PLANS AND DOCUMENTS referred to in the PDA DEVELOPMENT APPROVAL

PROJECT: AURA PRECINCT 15

DRAWING TITLE: INTERIM CAMCOS CROSSING

PROJECT No.	DRAWING No.	REVISION
21-000307	3015-SK123B	A

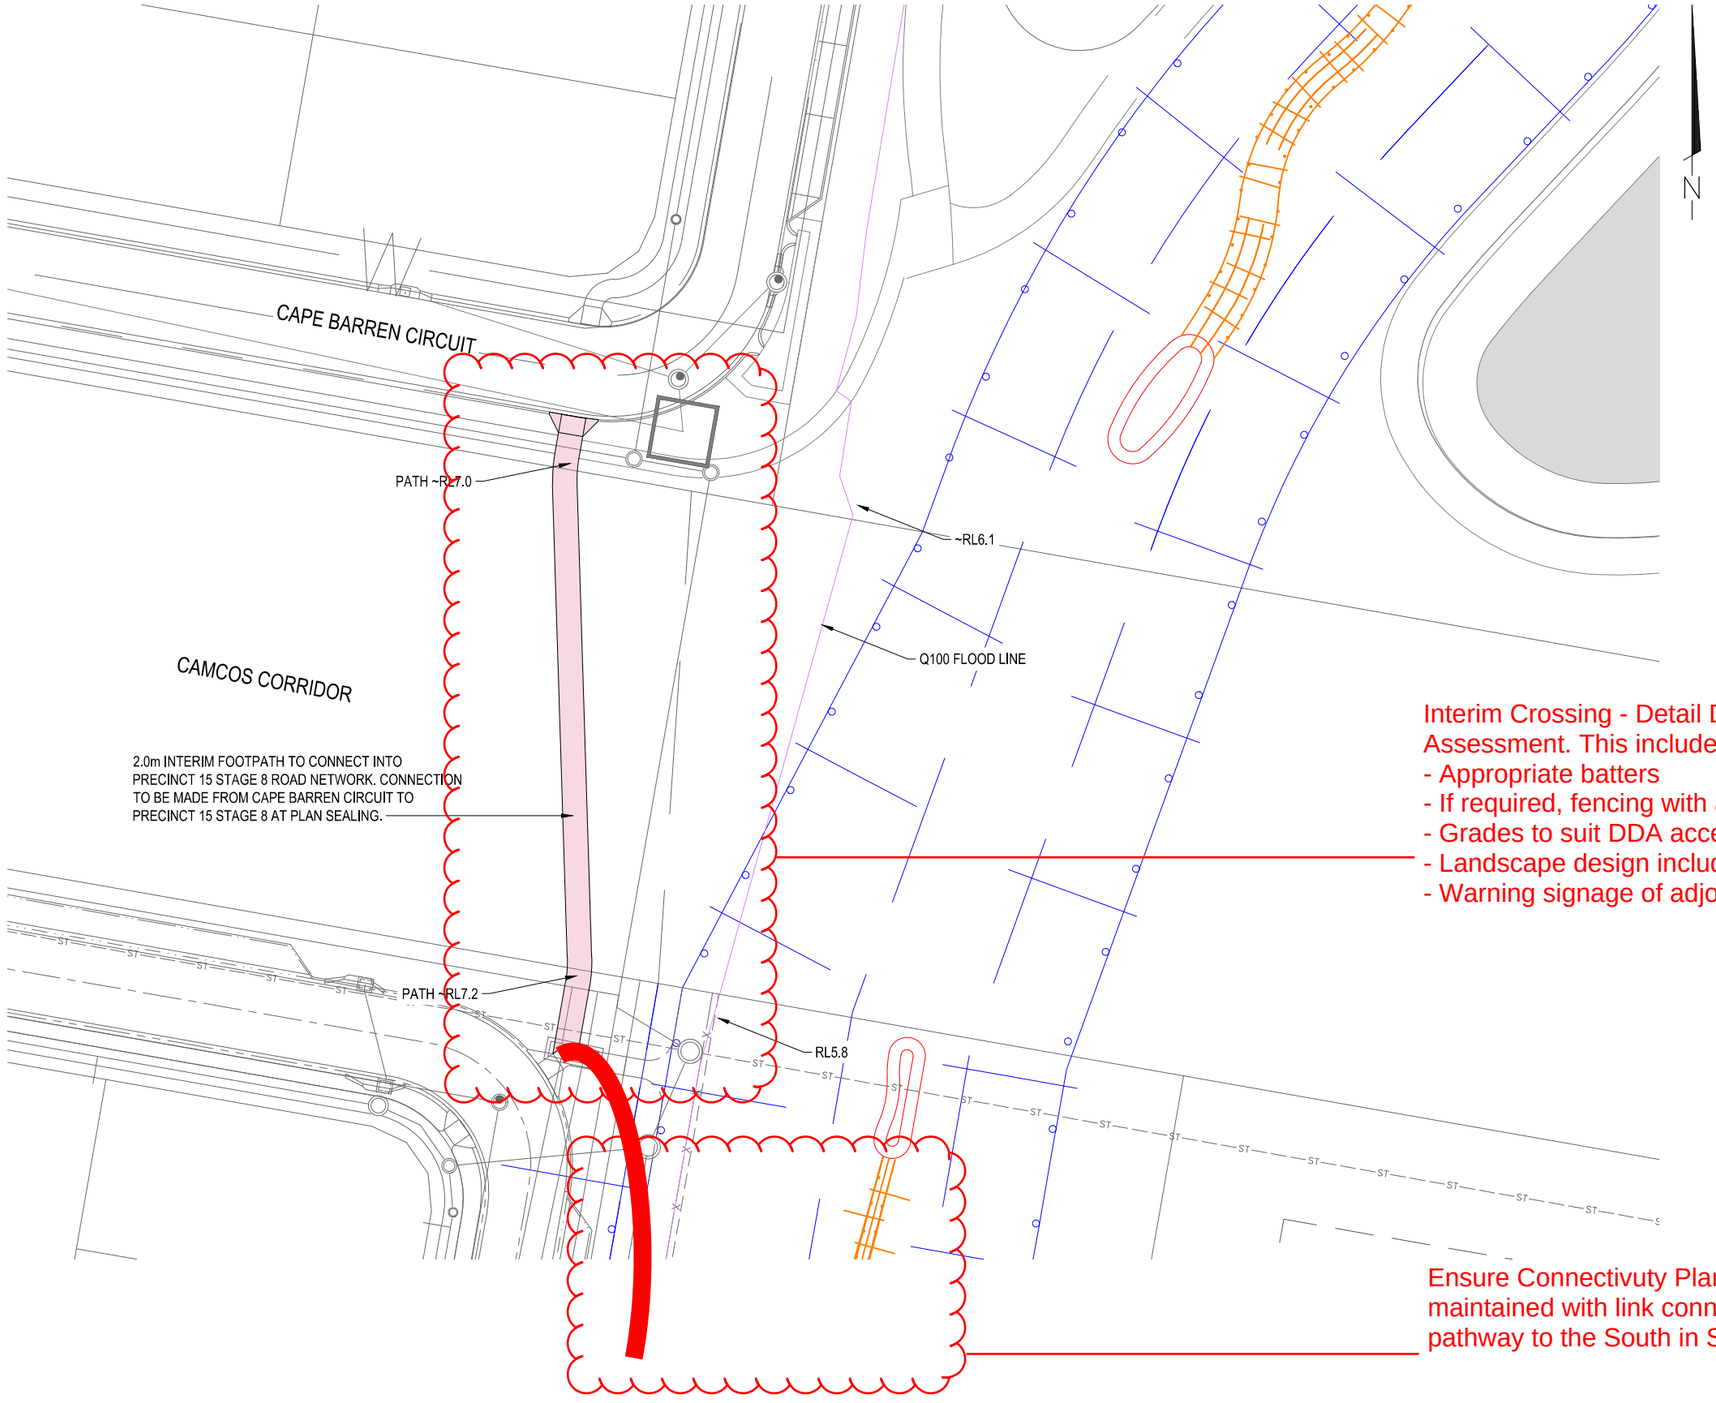
Interim Crossing - Detail Design subject to future Compliance Assessment. This includes, but not limited to:

- Appropriate batters
- If required, fencing with a minimum 50% transparency
- Grades to suit DDA accessibility
- Landscape design including appropriate shade planting
- Warning signage of adjoining flooding impacts

Ensure Connectivuty Plan intents are maintained with link connection to 3m shared pathway to the South in Stage 8c
